**From:** [Brian](#)  
**To:** [UTC DL Records Center](#)  
**Subject:** Comments on PSE's 2017 IRP Docket: UE-160918 and UG-160919  
**Date:** Tuesday, February 20, 2018 7:46:23 PM  
**Attachments:** [PSE IRP 2017 comments.pdf](#)

Docket: UE-160918 and UG-160919

Title: Chapter 8 of PSE's Integrated Resource Plan and WUTC's role in citizen protection

Figure 1 PSE's Electrocutation Zone

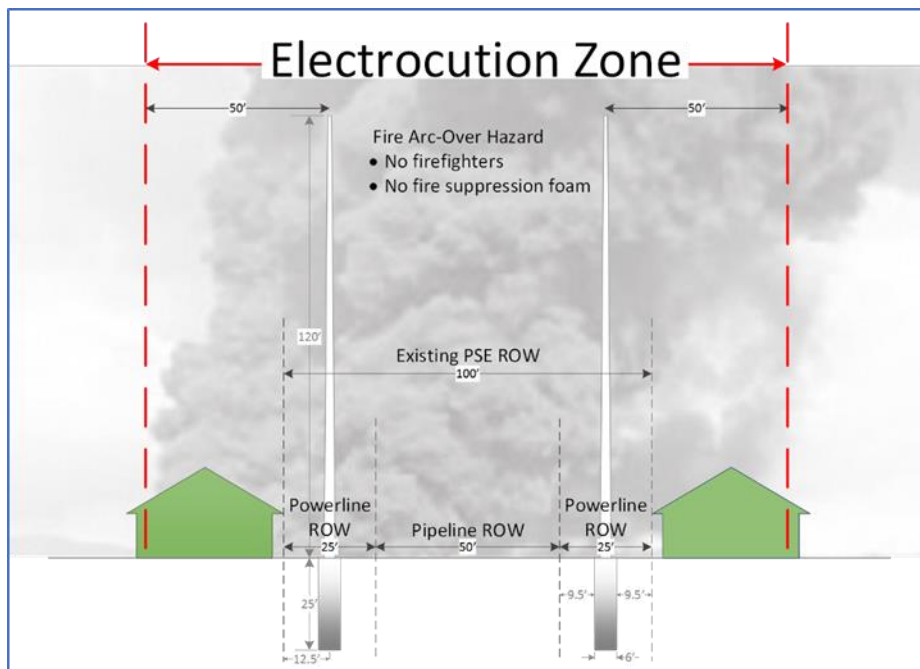
Foam is the one and only effective way to suppress a petroleum fire. But since foam is conductive, the mere presence of a PSE collocated 230 kilovolt transmission line prevents any viable attempt at safely suppressing a pipeline fire. As shown in Figure 1, the PSE collocated 230 kilovolt transmission lines straddling the pipeline creates an electrocution zone of death extending 50 feet from the 230 kilovolt transmission lines and supporting structures. When a catastrophic rupture of the hazardous liquid (petroleum) pipeline occurs, PSE's collocated 230 kilovolt transmission line could prevent any subsequent disaster recovery.

Since PSE is the sole design authority, safety risk is unbounded. On March 23, 2016, PSE threatened Newcastle that if setbacks for the towers from the pipeline corridor were required, PSE would zigzag the six high voltage conductors across the collocation corridor, crossing both hazardous liquid pipelines in multiple locations. PSE stated:

“And so, for example, if a 50-foot setback is adopted, then non-standard designs would be necessary. So, under this scenario, if existing transmission lines that are behind City Hall now were to meet such a standard, then we’d have about 20 houses that we’d need to condemn. And we’d zigzag throughout the corridor to make that happen.”

This would be at the worst case dangerous crossing angle. No rational person on planet earth would ever suggest such a dangerous configuration. But this is exactly what PSE stated on record they will do if we try to establish safe margins to protect ourselves in Newcastle. This is another mark of PSE’s complete incompetence, disregard for safety, and disregard for the public’s best interests. The DNV GL 2016 report does not address this very dangerous configuration. Bellevue’s EIS also does not address this very dangerous configuration. Bellevue has done insufficient research into the options that PSE’s considers viable. Bellevue’s EIS is deficient in not identifying the safety risks, safety risk mitigations, and the safety risk mitigation impact of the options PSE may pursue.

Figure 2 PSE's accelerated corrosion of the hazardous liquid pipeline at a coating flaw

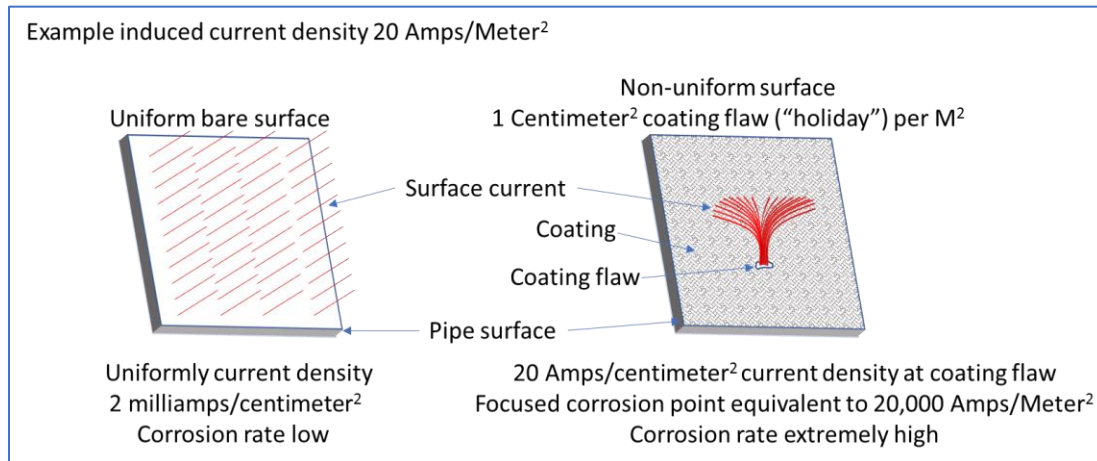
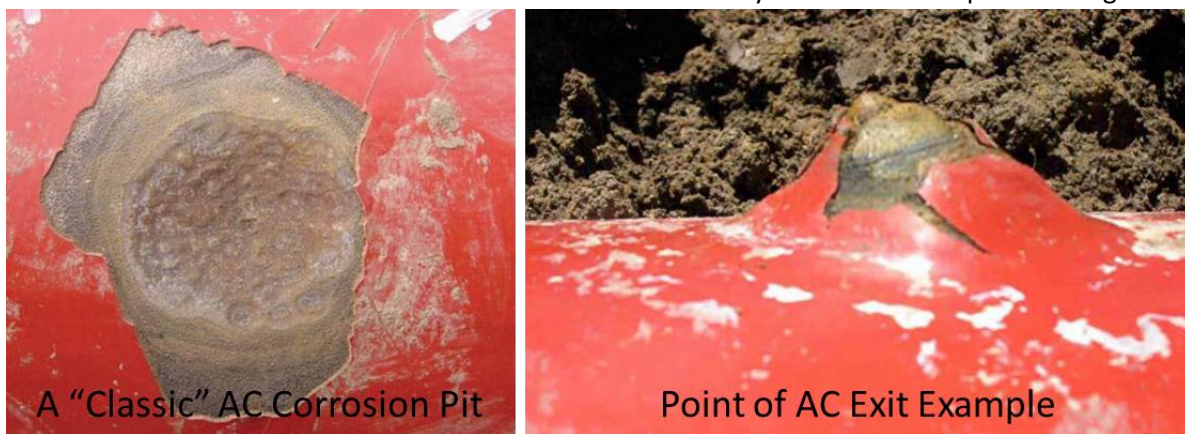
The referenced DNV GL 2016 report describes corrosion rates but not corrosion depth rate. The report fails to address the non-uniformity of current density and the high current density at flaws in the pipeline coating. The report states that below 20 Amps per square meter (meter<sup>2</sup>) current density, corrosion does not occur. This statement is extremely misleading in that it only applies to uniform current flow through the surface of the pipe. There are 10,000 square centimeters in a square meter (1 meter<sup>2</sup> = 10,000 centimeter<sup>2</sup>). Where average surface current over a square meter is concentrated at a square centimeter coating flaw the current density is magnified 10,000 times. At 20 Amps per square meter, one square centimeter coating flaw per square meter of surface would result in a localized current density equivalent to 20,000 Amps per square meter at each coating flaw as shown in Figure 2. This concentration of current density at a coating flaw accelerates the rate of corrosion though the

Corrosion depth rate is a significant safety risk issue. Corrosion depth rate indicates how rapidly the high pressure hazardous liquid pipeline wall is penetrated and fails. Per the Journal of Research of the National Institute of Standards and Technology Volume 115, Number 5, September-October 2010 corrosion depth rates have been measured as high as 1 millimeter per year. Per section 1.1.2 of the EDM services report in the draft phase 2 EIS the 20-inch outside diameter pipeline "is constructed of API 5L X52 grade, 0.250-inch wall thickness." The section states:

This is a five-year interval between inspections. During this interval, corrosion depth at a one square centimeter flaw in the pipeline coating could penetrate 5 millimeters (0.197 inches) into a 0.250 inch thick pipe wall. This leaves 0.053 inches (13 sheets of paper thickness) of corroding material holding back 500 PSI of toxic and flammable hazardous liquid. 79% of the pipeline wall thickness would be corroded away. That applies to a pipe that is in new condition with uniformly full wall thickness. The scenario is much worse for a nearly half century old pipe that isn't in new condition. This is a life-threatening game of chance where PSE always wins and we lose.

The EIS is defective in that it does not address this critical safety issue and the impact of mitigation.

Figure 3 Annual minimum ambient temperature day history

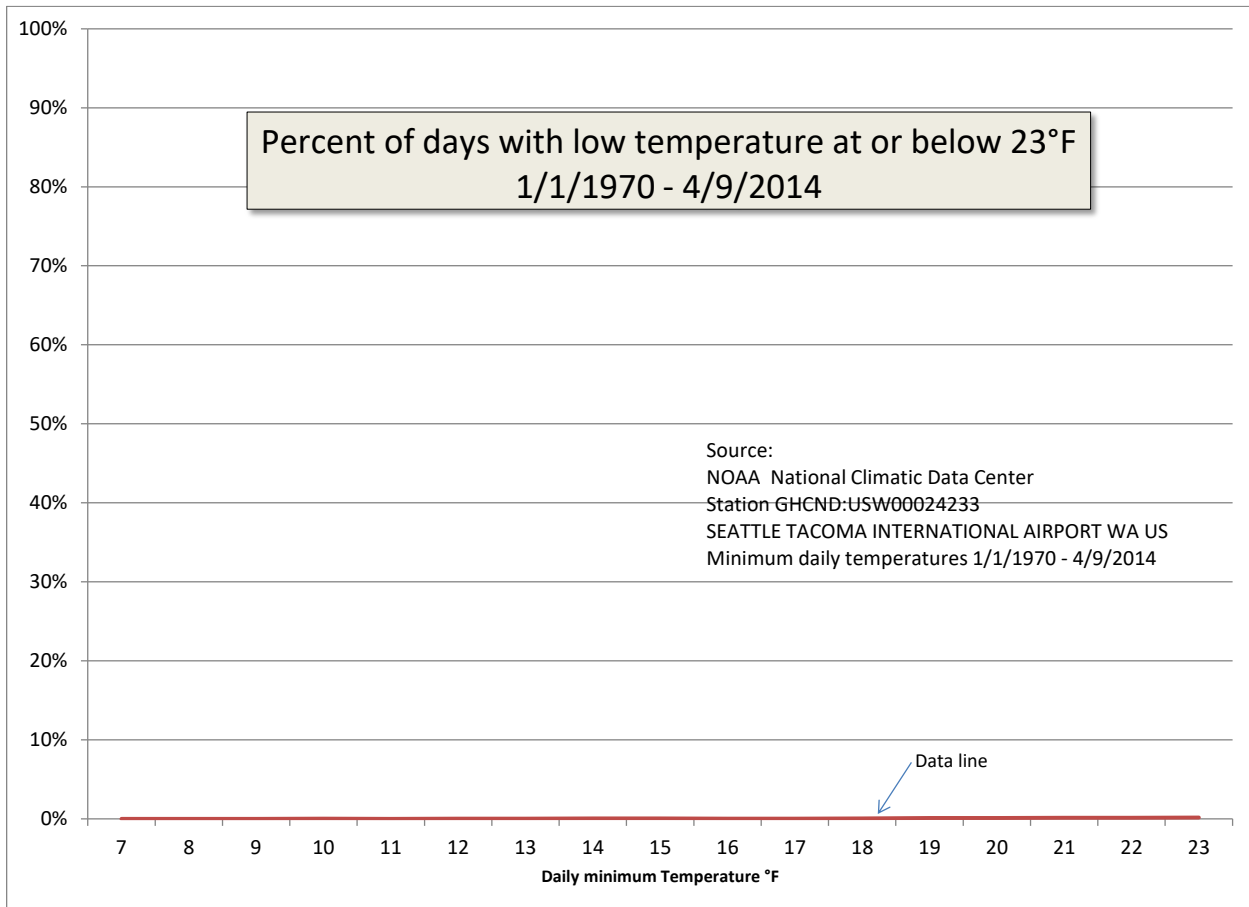
The NOAA National Climatic Data Center has a database of daily minimum temperatures for Station GHCND:USW00024233 SEATTLE TACOMA INTERNATIONAL AIRPORT WA US. Figure 3 is a summary of 16170 daily minimum temperature measurements in a period between January 1, 1970 and April 9, 2014. The horizontal scale is the daily minimum temperature in one-degree Fahrenheit increments from the lowest measured value in the period (7°F) to 23°F. The vertical scale ranges from 0% to 100% and is the percentage of the period in which each minimum temperature was recorded.

Since the occurrences of 23°F and lower temperatures days are extremely infrequent an expanded view of the bottom 1% is provided in Figure 4.

Figure 4 Annual minimum ambient temperature day history - Expanded view

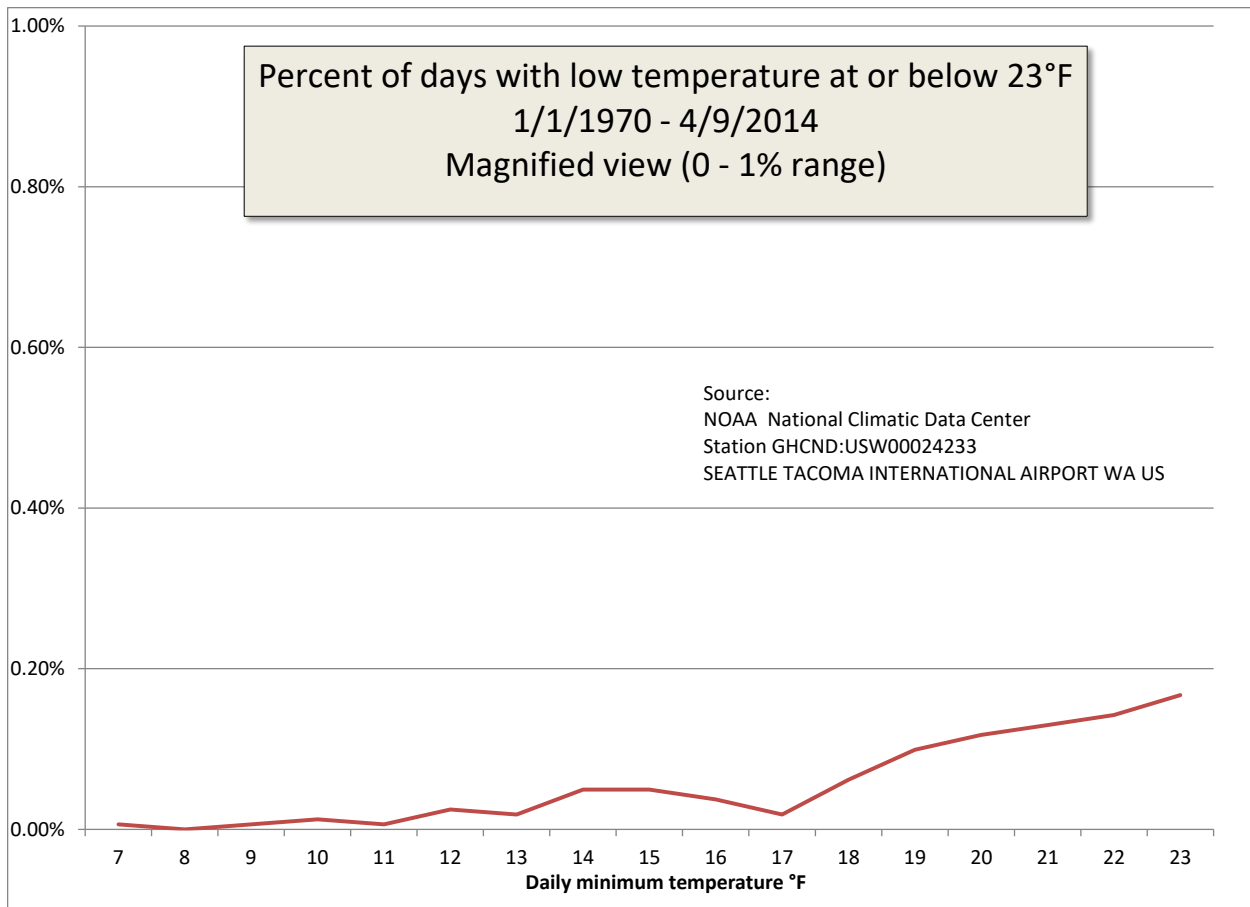
As can be deduced from the charts, the extreme conditions identified by PSE are very infrequent. The total percentage of days with minimums at or below 23°F is 0.95% (less than 1% of the time, or 3.5 days per year) for the entire period. This suggests that the problem stated by PSE is potentially solvable within the realm of smart power management policies without resorting to the unnecessary options within PSE’s narrow solution space. PSE has offered no defensible justification for excluding employment of a smart power management approach.

Figure 5 PSE's solution versus stated need in perspective

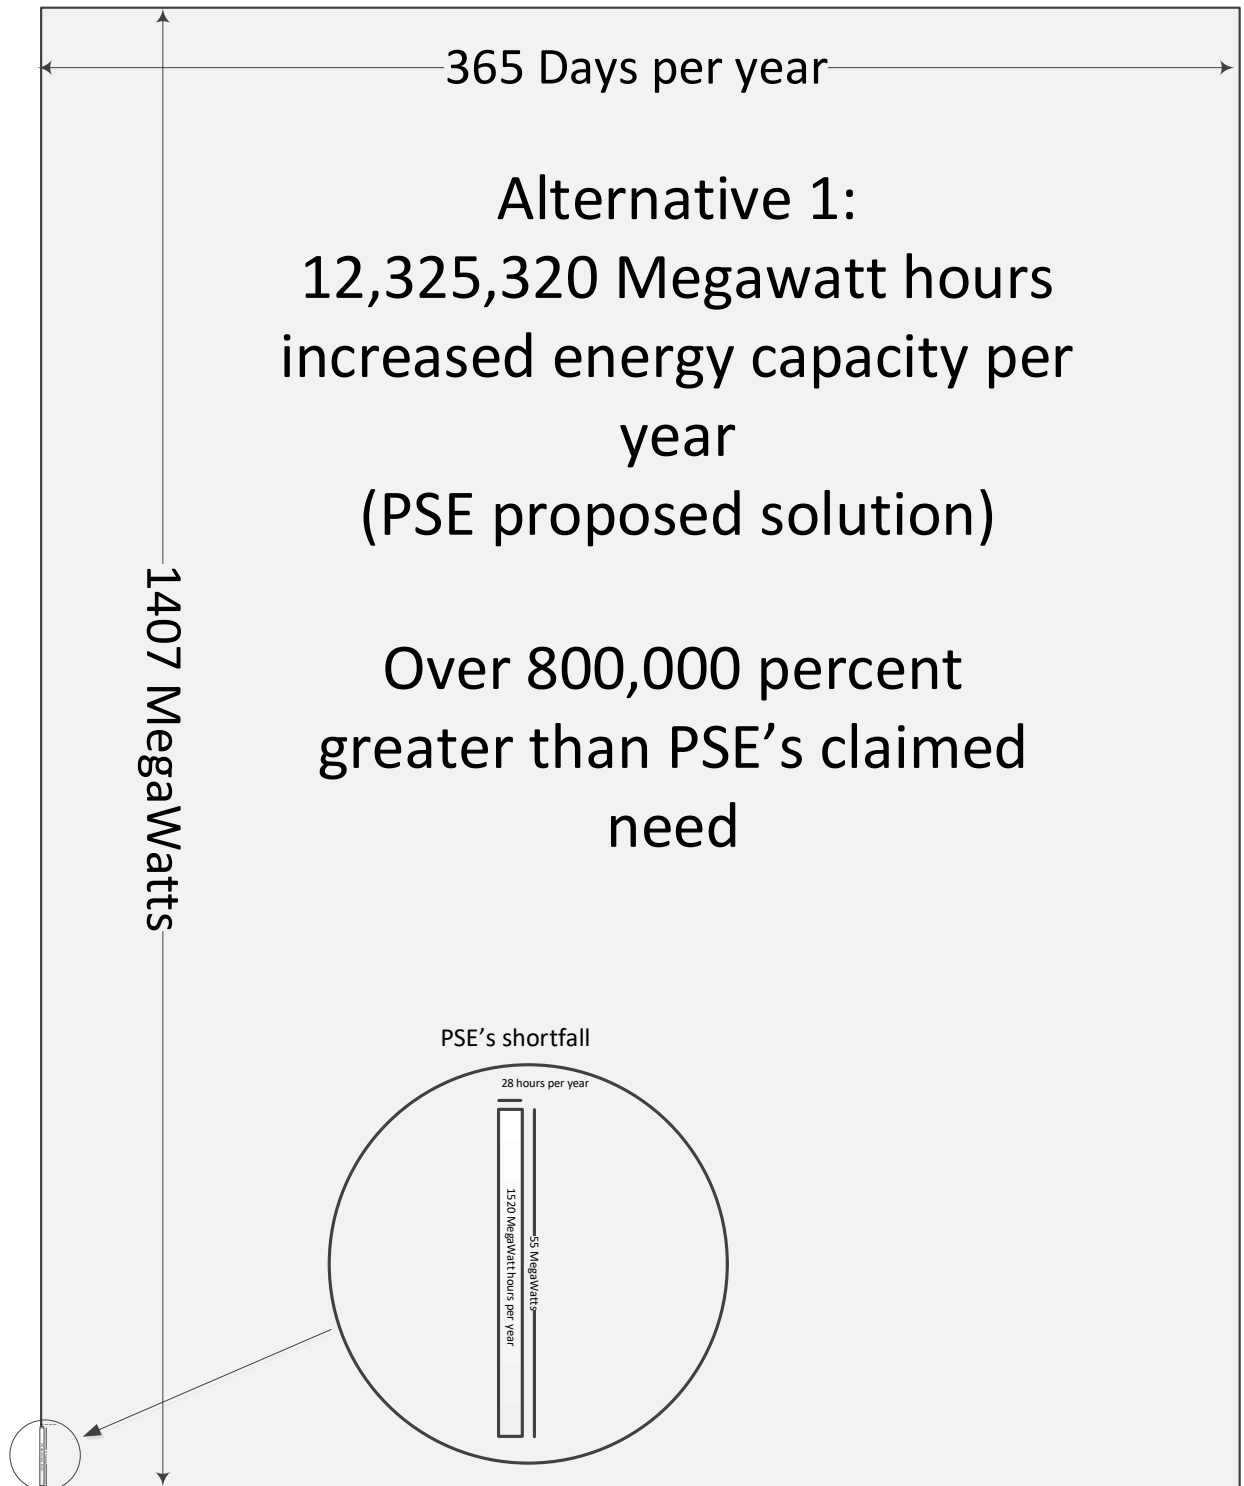
Figure 5 shows the relative scale of PSE's proposed project versus PSE's statement of need during the CAG process. To be clear, the percent increase in capacity vs need as stated above is over 800,000 percent. An increase of this magnitude will never ever be needed in the PSE customer base area.

If the capacity were scaled to the height of the Space Needle (605 feet) the need could be represented by a stack of 15 pennies (0.895 inches). If those pennies were placed on the ground at the base of the Space Needle, they would be too small to see from the top.
